Re: Bible Baptist Church-Special Land Use and Site Plan Review

Please find enclosed a revised project submittal for the Bible Baptist Church project. Included are revised site plans, a revised impact assessment, and an additional Special Use permit application for the encroachment in the 25' natural features setback.

FOREBAY DETAILS

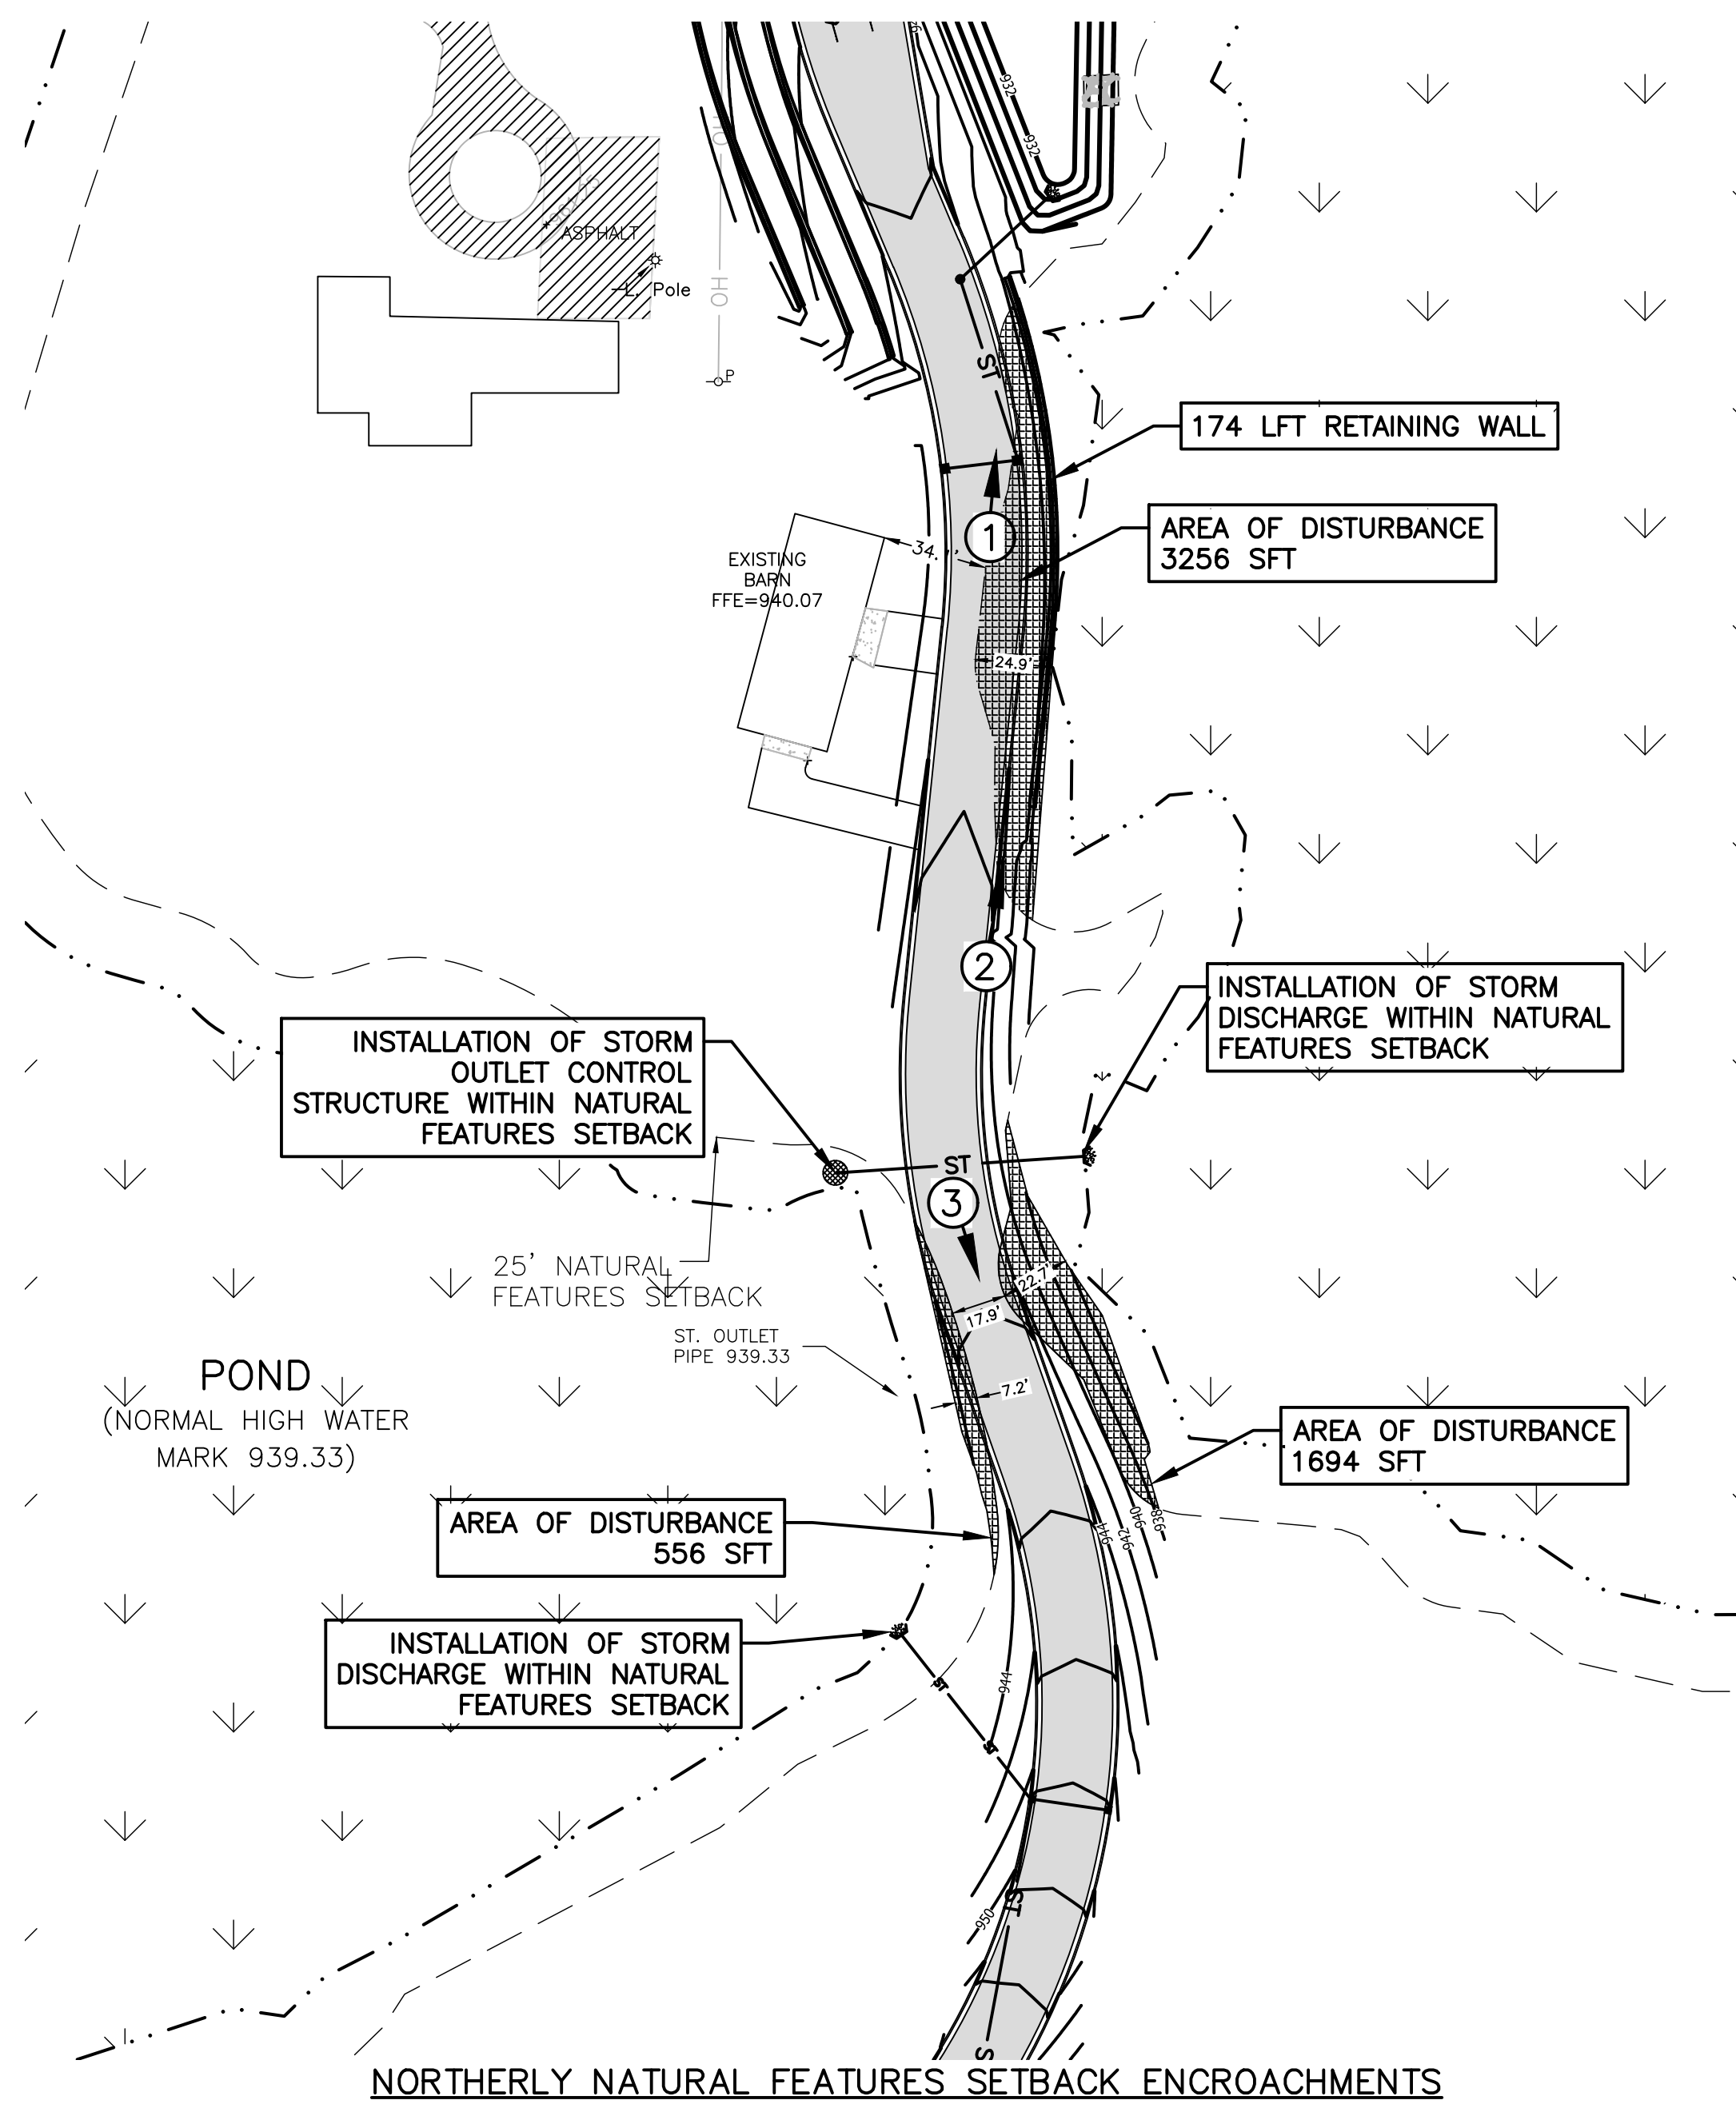
- 3) More detail has been added to the mechanical pretreatment structure detail as requested.
- 4) Storm Structure and pipe sizes have been added to the utility plan.

NATURAL FEATURES SETBACK DISTURBANCE

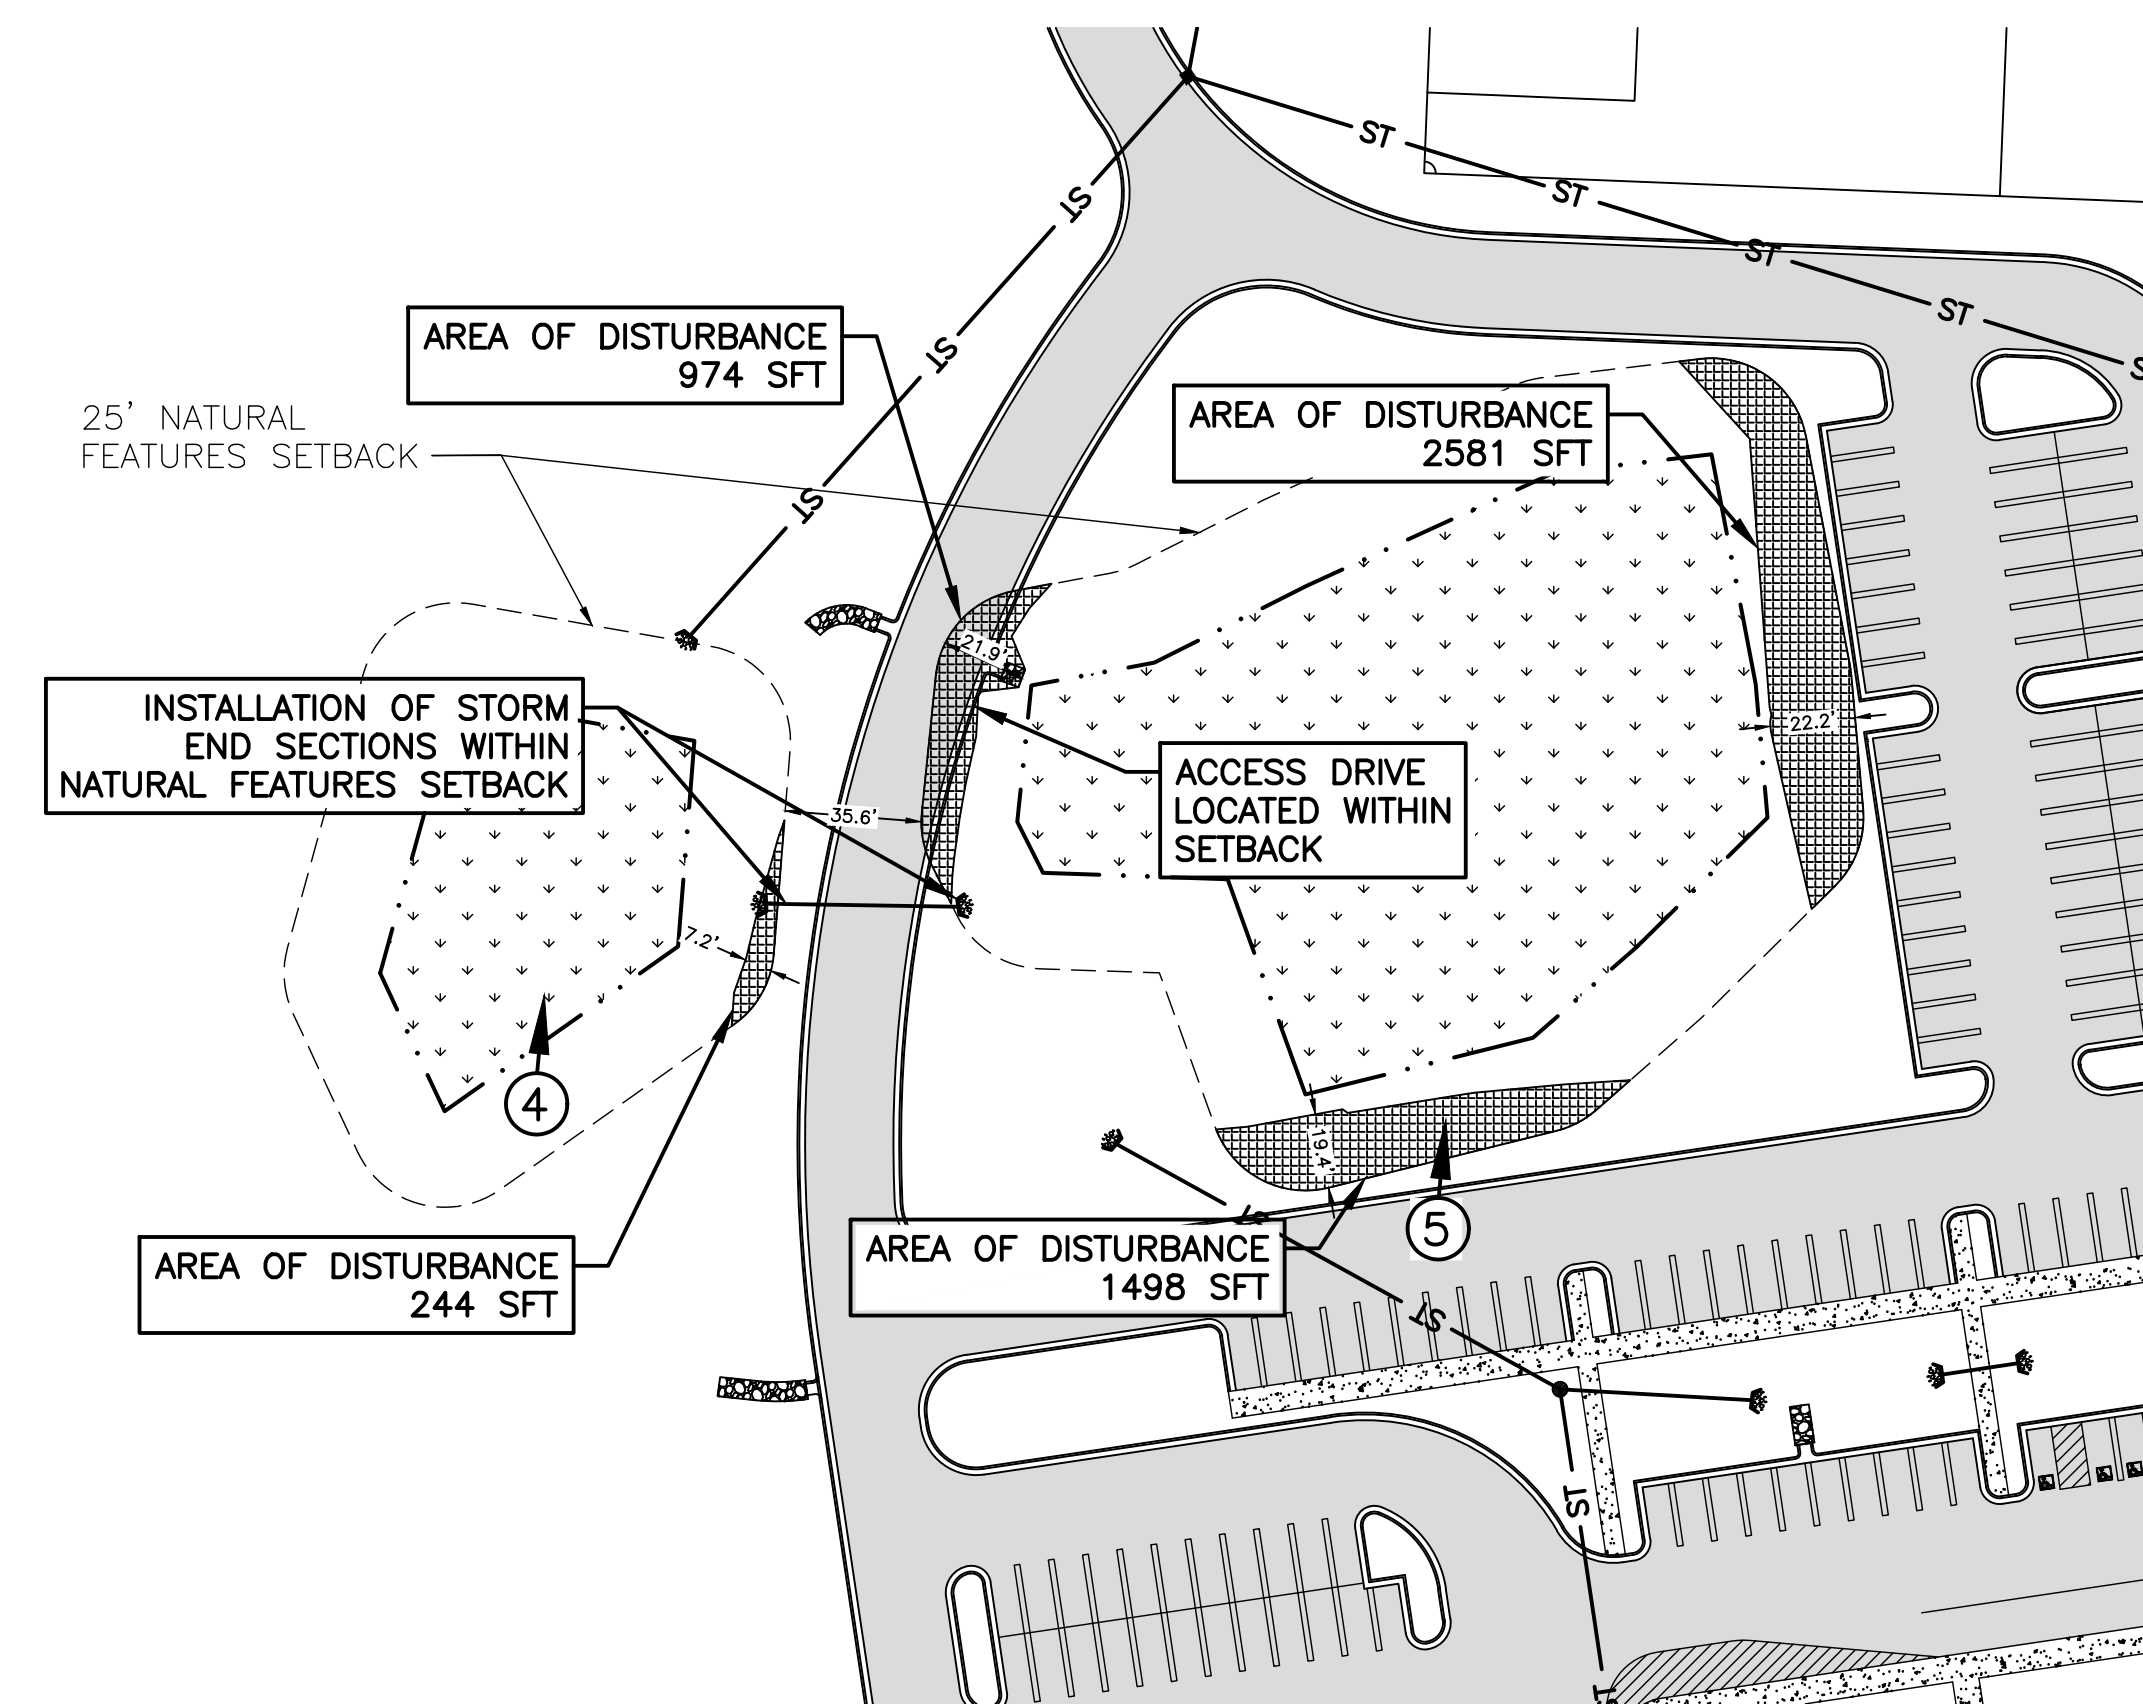
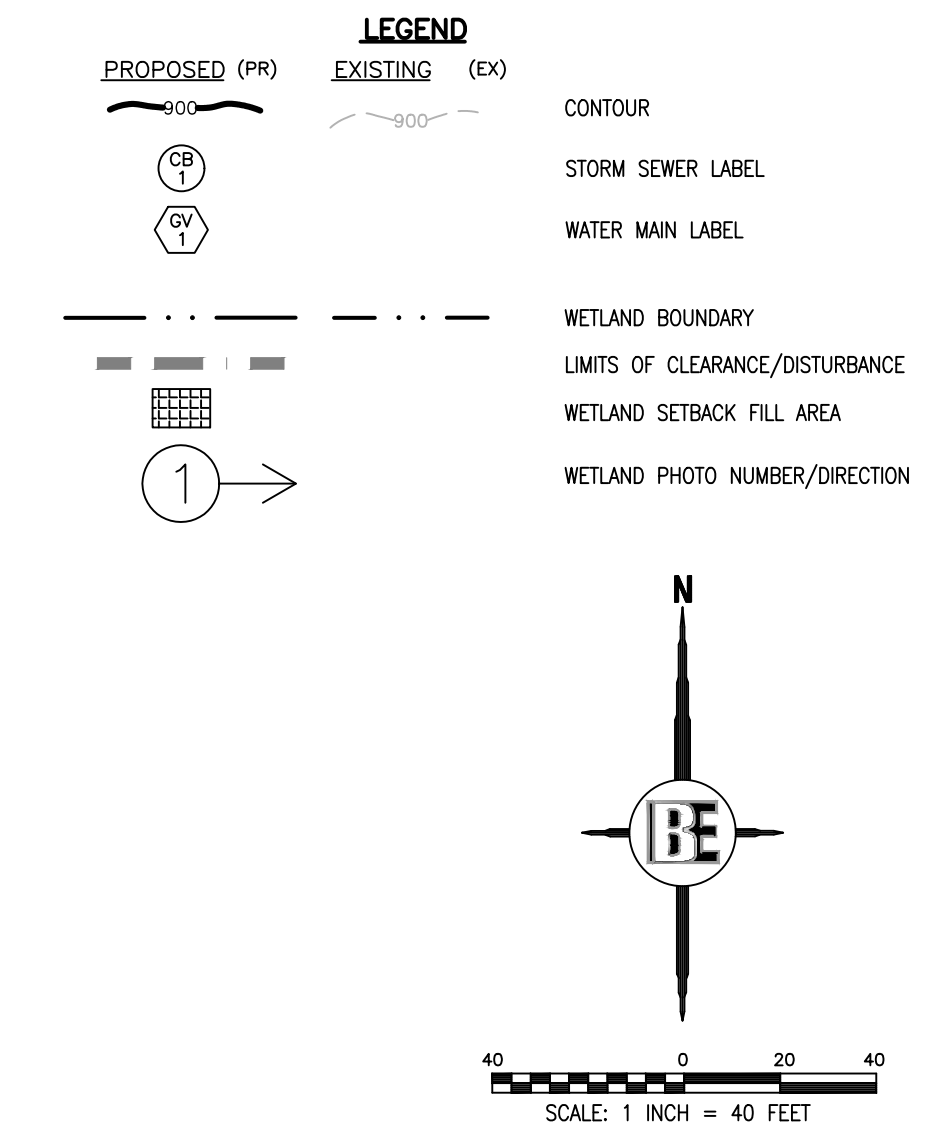
- 7) A sheet has been added near the end of the plan set specifically for the natural features setback encroachments. This sheet notes all locations of encroachments as well as areas of encroachment delineated for grading purposes.
